MEMORANDUM

To: Garrett Martin, Milestone Community Builders & Caitlin Adnire, Norris Design
From: Louis Alcorn, Capital Metro Planning
Date: 9 November 2015
Subject: RESPONSE - Site Evaluation for Potential Future Bus Stop Placement (*The Grove at Shoal Creek*)

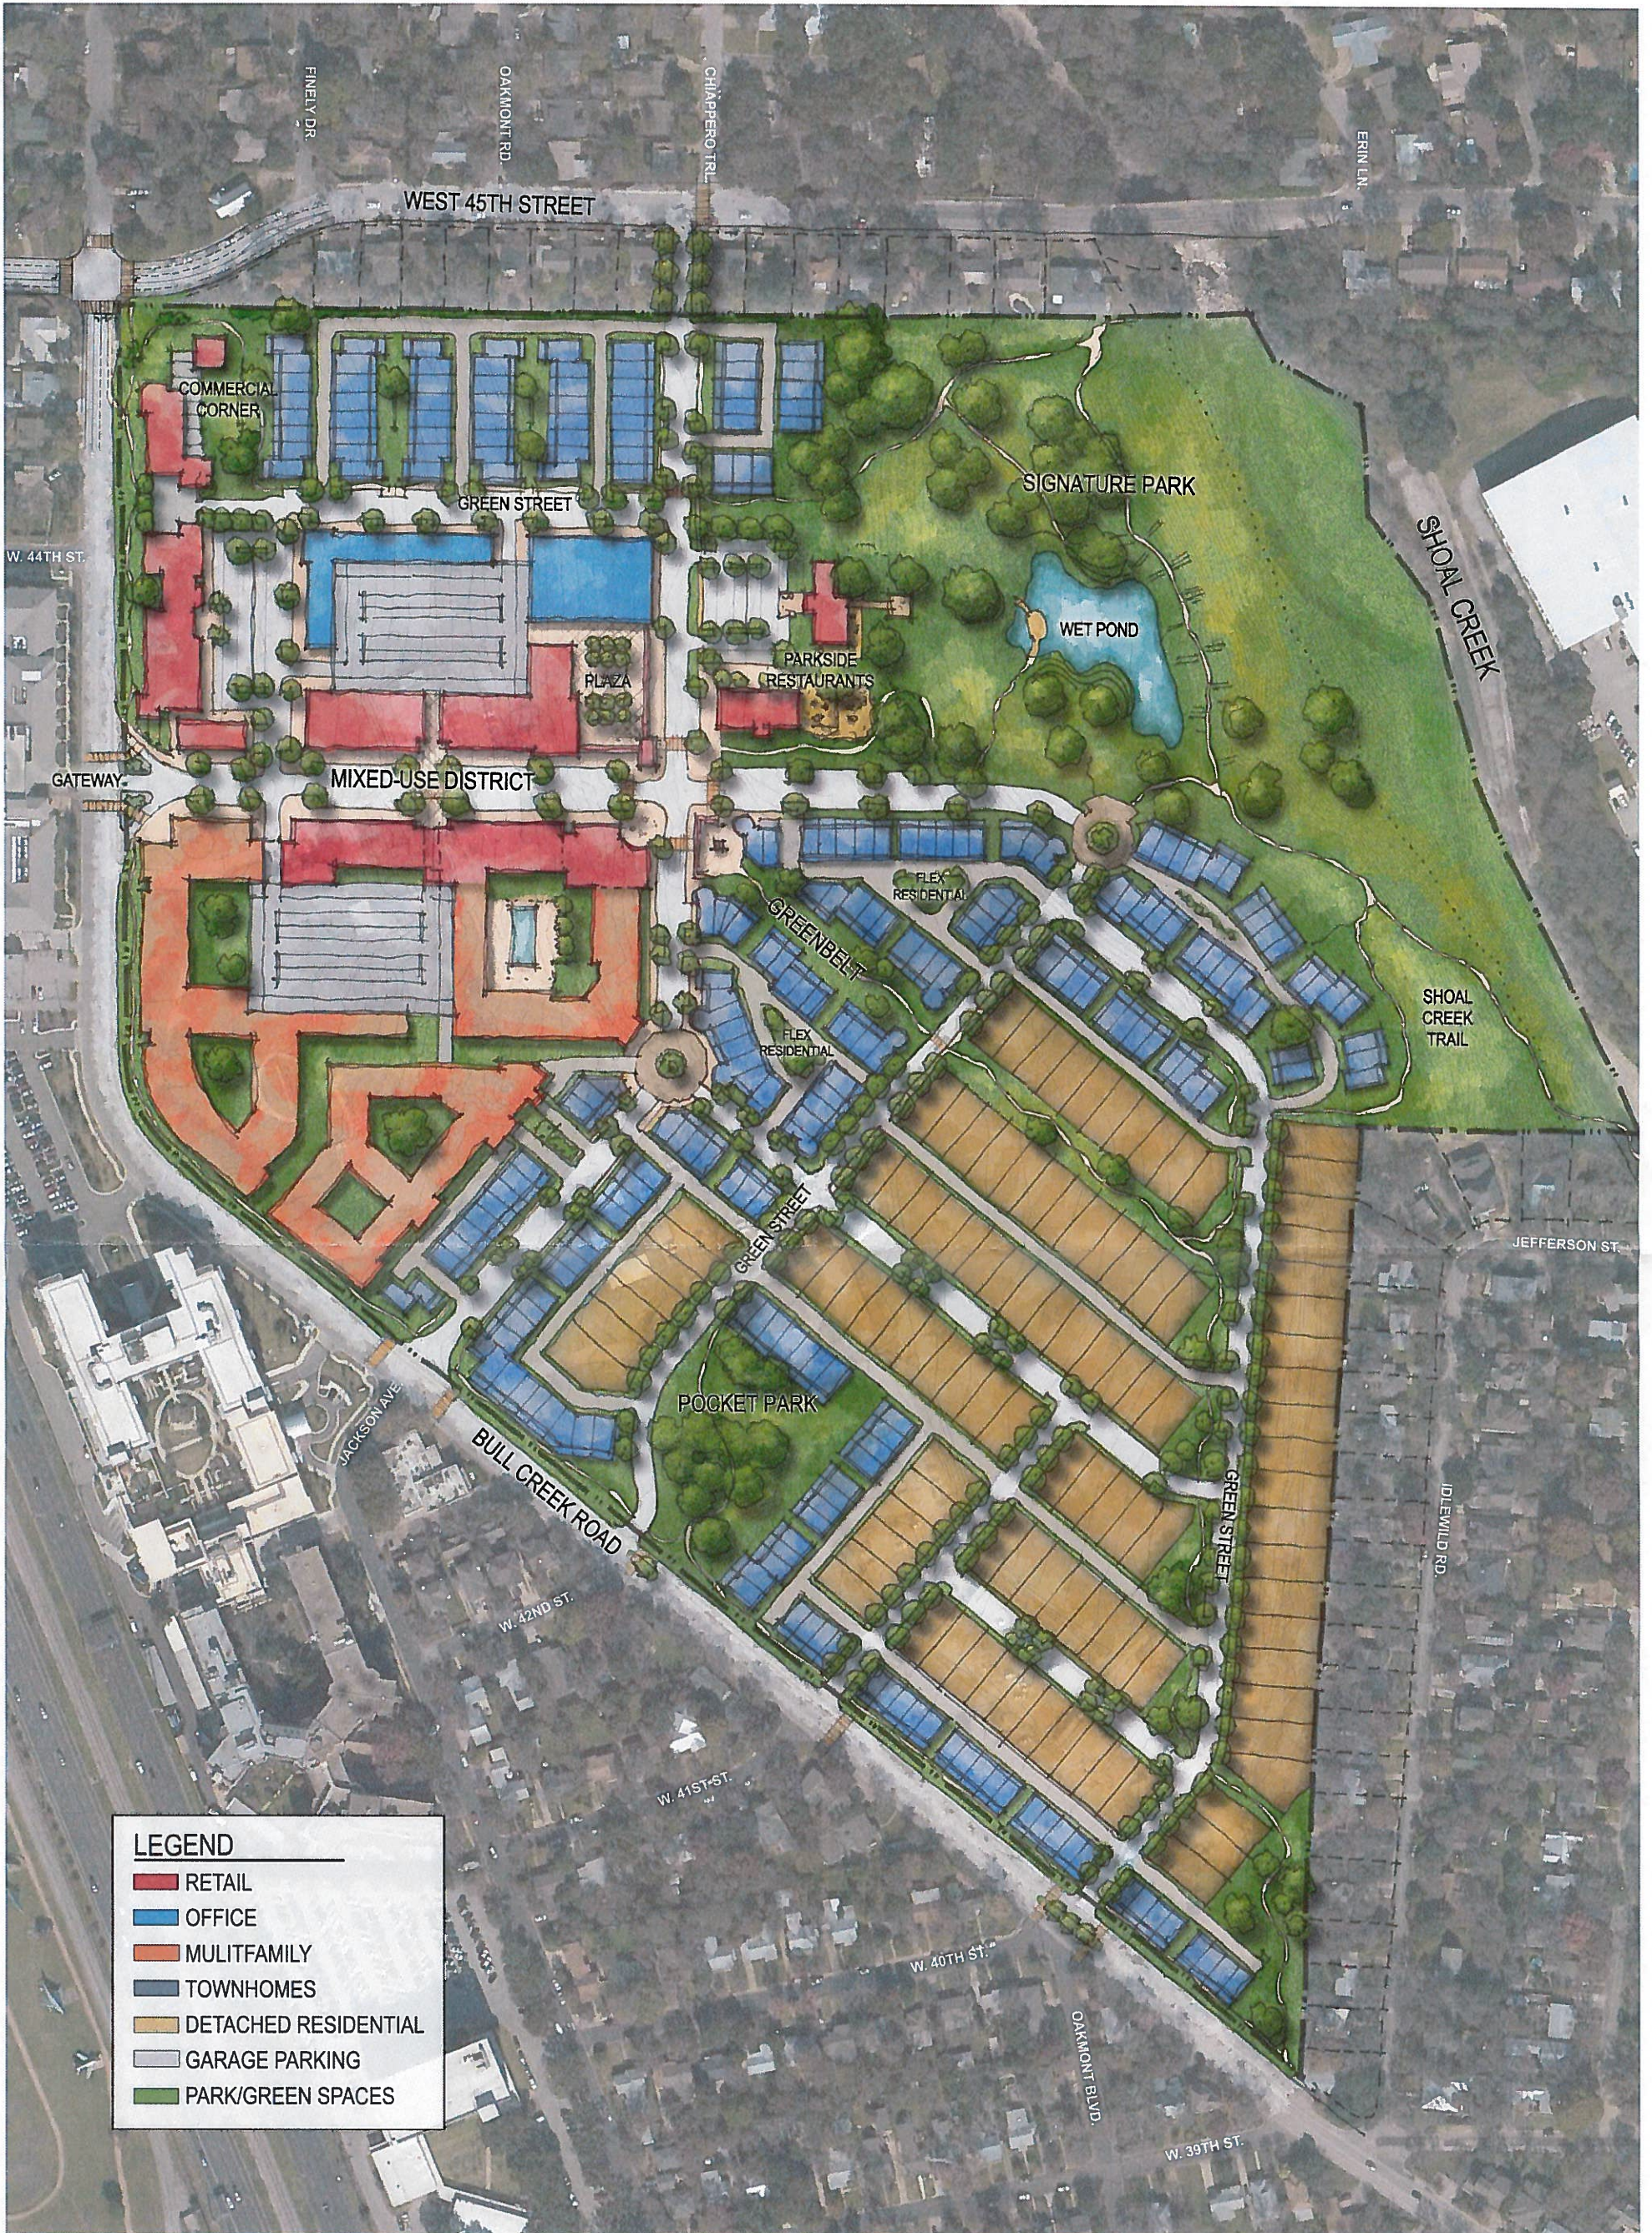
As per the Fall 2015 Update to our Service Guidelines and Standards, stop spacing in an area with medium density should generally be a minimum of 1,200 feet. This being said, the following map depicts our proposed bus stop placements, including the potential to relocate the W 45th & Bull Creek NB stop up to 300 feet south of its current location.

Bus stops should be approximately 25 feet in length by 10 feet in width and incorporated into the sidewalk. A larger area of approximately 15 feet in width (perpendicular to the road by 50 feet in length (parallel to the road) surrounding the stop should maintain a level slope to ensure that all ADA slope requirements are met.
